Re: Defect Information Notice FL-501, ACC axle Steering Arm Bolts

Defect Information Report
(Section 573.6)

Subject: AAC Front Axle Tie Rod and Steering Arm Fasteners

December 2007
FL501A
NHTSA #07V-306

Fig. 1, Steering Arm and Tie Rod Arm

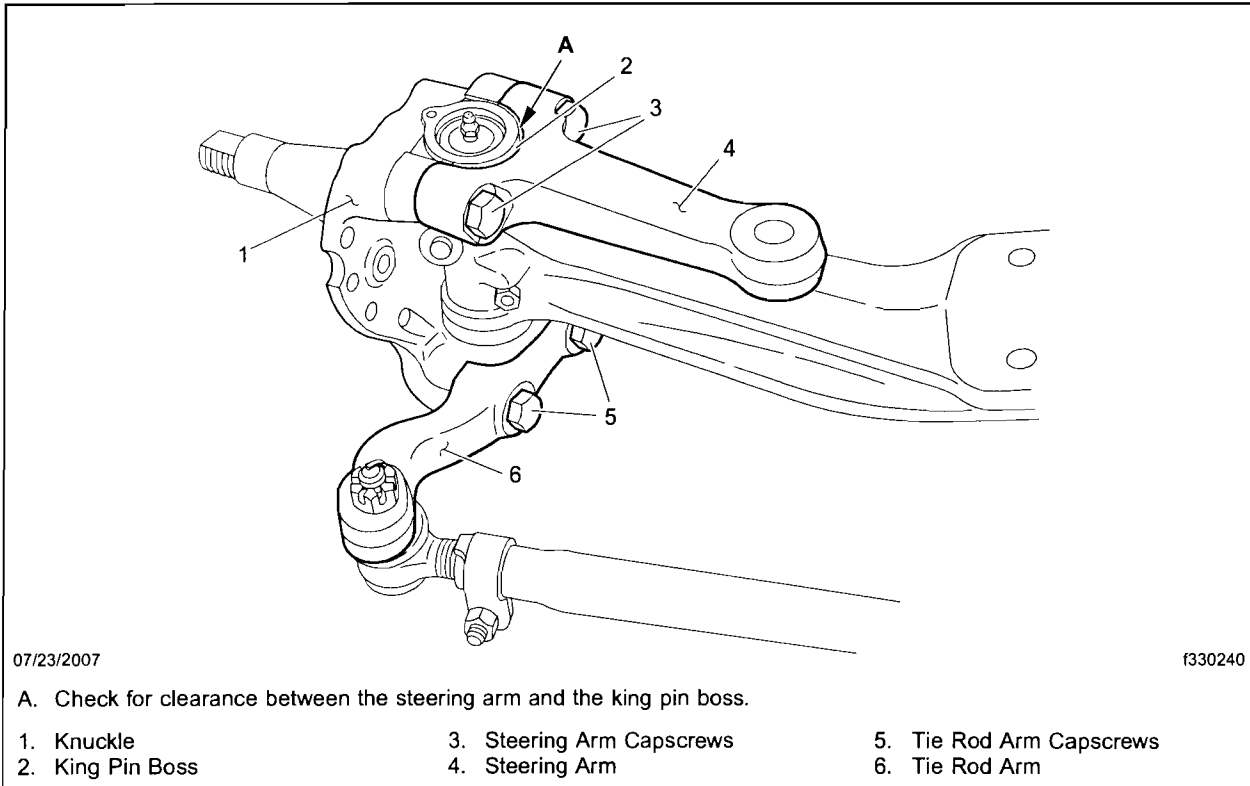
1. Check the base label (Form WAR259) for a completion sticker for FL501 (WAR260) indicating this work has been done. The base label is usually located on the passenger-side door about 12 inches (30 cm) below the door latch on trucks, over the driver's window in school buses, on the front wall under the dash in motorhomes, or in the driver's area in step vans. If a completion sticker for FL501 is present, nothing more needs to be done. If no sticker is present, go to the next step.
2. Shut down the engine, and chock the front tires.
3. Using a 0.004 inch (0.1 mm) feeler gauge, check the clearance between the steering arm and the king pin boss. See **Fig. 1**.

1. Remove one of the capscrews that attaches the steering arm to the steering knuckle. See **Fig. 1**.
2. Check the capscrew threads to verify whether Loctite[®] or another thread locking compound was applied to them.

1. Remove one of the capscrews that attaches the tie rod arm to the knuckle. See **Fig. 1**.
2. Check the capscrew threads to verify whether Loctite® or another thread locking compound was applied to them.

3. Apply Loctite 277 to the threads of a new M20 x 1.5 x 80 capscrew from the Recall kit.
4. Install the new steering arm capscrew and tighten it 425 lbf-ft (575 N-m).
5. Repeat steps 1 through 4 to replace the second capscrew.
6. Continue with the "Tie Rod Arm Capscrew Replacement" procedure in these Work Instructions.

3. Apply Loctite 277 to the threads of two new M20 x 1.5 x 80 capscrews.
4. Install a new steering arm with its engraved part number facing upward.
5. Install the new steering arm capscrews and tighten them 425 lbf·ft (575 N·m).
6. Go to the "Tie Rod Arm Capscrew Replacement" procedure in these Work Instructions.
